Amendments to the Drawings:

Attachment: Replacement Sheets for Figs. 1, 2, and 5
Annotated Sheet Showing Changes

FIG. 1

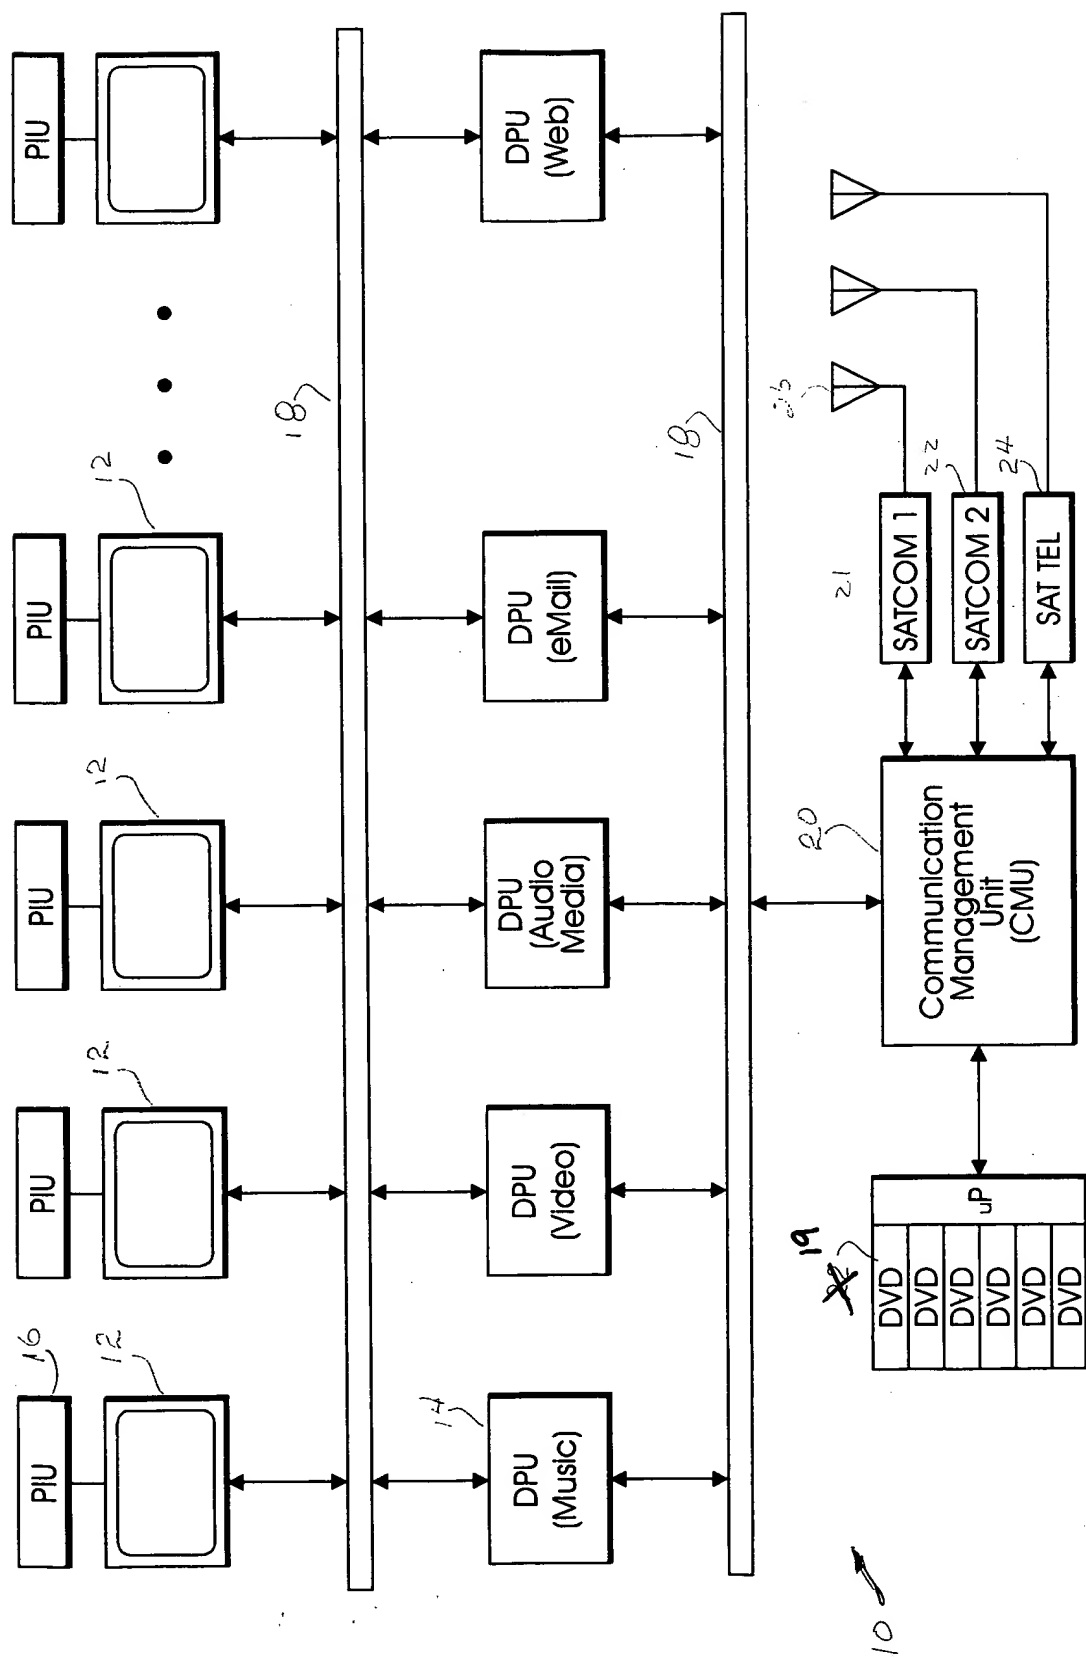
The attached sheets of drawings includes changes to Figs. 1, 2, and 5. These sheets, which includes Figs. 1, 2, and 5, replace the original sheets including Figs. 1, 2, and 5. In Figs. 1 and 2 the DVD 22 has been changed to DVD 19, and in Fig. 5 element 70 has been changed to element 71.

In the Office Action mailed July 18, 2003, the Examiner objected to the drawings of the present application. The drawings were objected to as failing to comply with 37CFR 1.84(p)(4) because reference character "18" had been used to designate both the upper and lower bus in Fig. 1. Also in Fig. 1, reference character "22" points to a DVD stack and SATCOM2. Further, in Fig. 5, reference character "70" points to the HDD and the NID. In addition, the Examiner objected to the drawings as failing to comply with 37 CFR 1.84(p)(5) for failing to mention the reference sign "64" in the description. The Examiner also objected to Fig. 1 because the top bus 18 separates the processors from the displays contrary to claim 1, and objected to Fig. 2 on the grounds that the displays (12) are shown and not the processors/memory (14) contrary to claim 1.

In response, the Applicant has amended Figs. 1, 2, and 5 and the specification of the present application. The Applicants respectfully submit that no new matter has been added. In addition, the Applicant respectfully submit that the specification of the present application states:

"[I]n the particular exemplary embodiment of FIG. 1, the signal bus 18 is depicted as lying between the multiplicity of DPUs and the multiplicity of display units, as well as between the multiplicity of DPUs and a communication management unit (CMU) 20. The particular configuration of the embodiment of FIG. 1 is solely for purposes of illustration and ease of explanation and is not intended to imply that there are two separate signal busses. Indeed, only a single network

bus is contemplated by the present invention, with the network bus interconnecting the multiplicity of electronics packages with, for example, an aircraft communication management unit 20."

FIG. 2

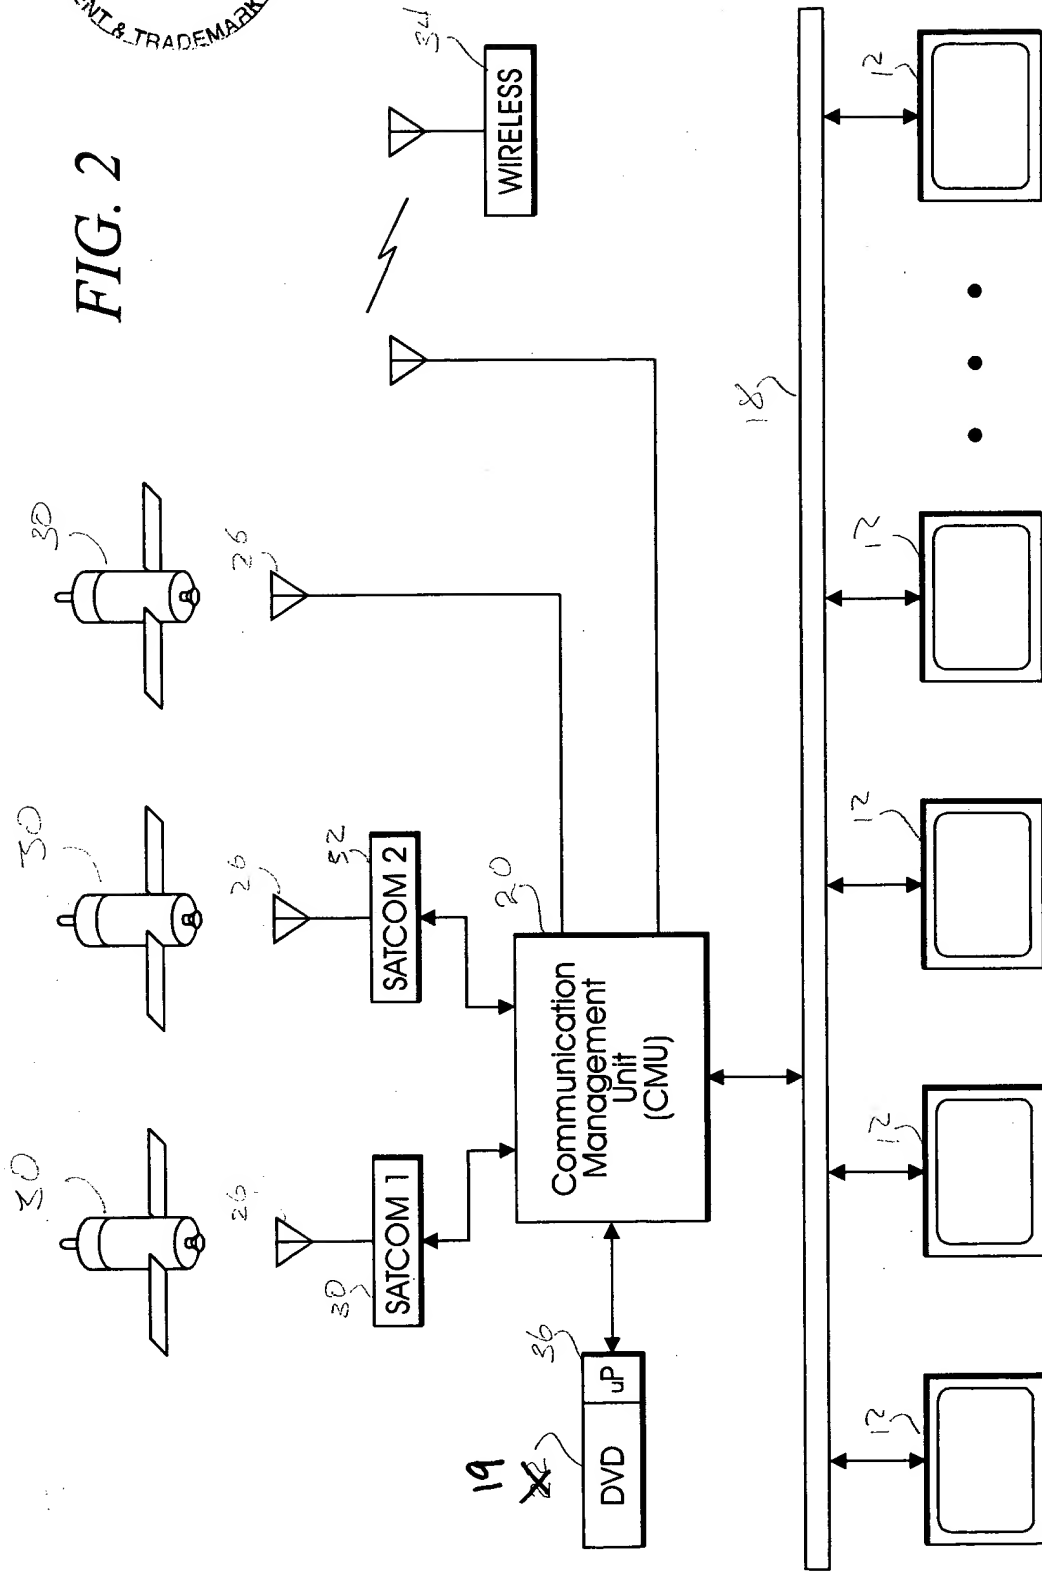
With respect to the Examiner's objection to Fig. 2 on the grounds that the displays (12) are shown and not the processors/memory (14) contrary to claim 1, the Applicant respectfully directs the Examiner's attention to the specification of the present invention which states:

"Although depicted in the exemplary embodiment of FIG. 1 as being separate from the display unit 12, the DPU 14 might well be integrated with the display in a complete electronic subassembly that, together with a suitable housing, can be inserted into a suitable receptacle provided any convenient location on the rear side of a passenger seat."
